Project	IEEE 802.16 Broadband Wireless Access Working Group < http://ieee802.org/16 >	
Title	QoS Control Scheme for data forwarding in 802.16j	
Date Submitted	2007-05-10	
Source(s)	<p>Hang Zhang, Peiyong Zhu, Mo-Han Fong, Wen Tong, David Steer, Gamini Senarath, Derek Yu, Mark Naden, G.Q. Wang</p> <p>Nortel 3500 Carling Avenue Ottawa, Ontario K2H 8E9</p> <p>Ranga Reddy US Army - CERDEC, USA</p> <p>D. J. Shyy MITRE, USA</p> <p>Arnaud Tonnerre</p> <p>THALES COMMUNICATIONS, FRANCE</p> <p>Djamal-Eddine Meddour</p> <p>FRANCE TELECOM, FRANCE</p> <p>Jeffrey Z. Tao, Koon Hoo Teo, Jinyun Zhang</p> <p>Mitsubishi Electric Research Lab 201 Broadway Cambridge, MA 02139 USA</p> <p>Toshiyuki Kuze</p> <p>Mitsubishi Electric Corp 5-1-1 Ofuna Kamakura, Kanagawa 2478501, Japan</p> <p>Aik Chindapol Jimmy Chui Hui Zeng Siemens Corporate Research Princeton, NJ, 08540, USA</p> <p>Teck Hu Siemens Networks Boca Raton, FL 33431, USA</p> <p>Yuan-Ying Hsu Telcordia Applied Research Center Taiwan Co., Taipei, Taiwan</p> <p>Tzu-Ming Lin, Fang-Ching Ren, Chie Ming Chou, I-Kang Fu ITRI/ NCTU Taiwan 195, Sec. 4, Chung Hsing Rd. Chutung, Hsinchu, Taiwan 310, R.O.C.</p> <p>Torsten Fahldieck Alcatel-Lucent R&I Holdera

Figure 1. Relay MAC header format with proposed 3-bit “priority field”

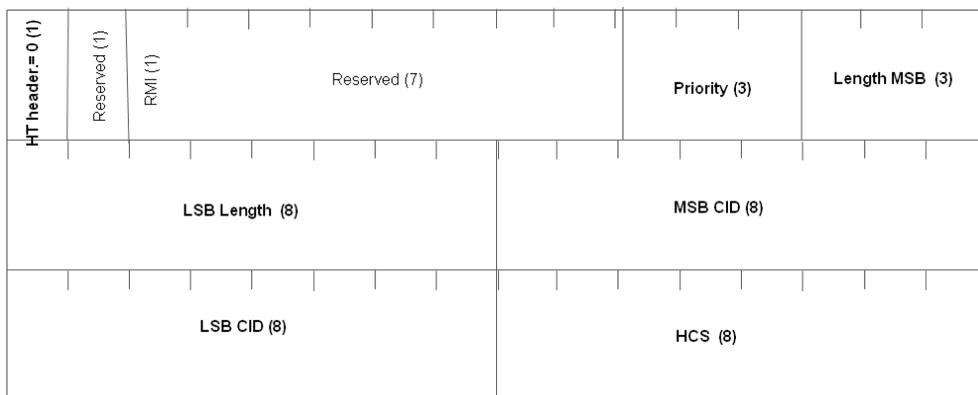
1. Use 3 bits in the “reserved field” of the relay MAC header defined in 07/198r8 as a “priority field” to indicate the priority of the associated MPDU.
2. This 3-bit “priority field” is used for RS to prioritize the data traffic along the relay path between BS and access RS
3. This approach is applicable to distributed scheduling relay system

Figure 1 below provides an example of where the 3-bit “priority field” could be in the relay MAC header specified in 07/198r8.

3-bit “priority field” may be used in the relay MAC header to indicate the priority of the associated tunneled MPDU. The location of “priority field” in relay MAC header is to be determined.
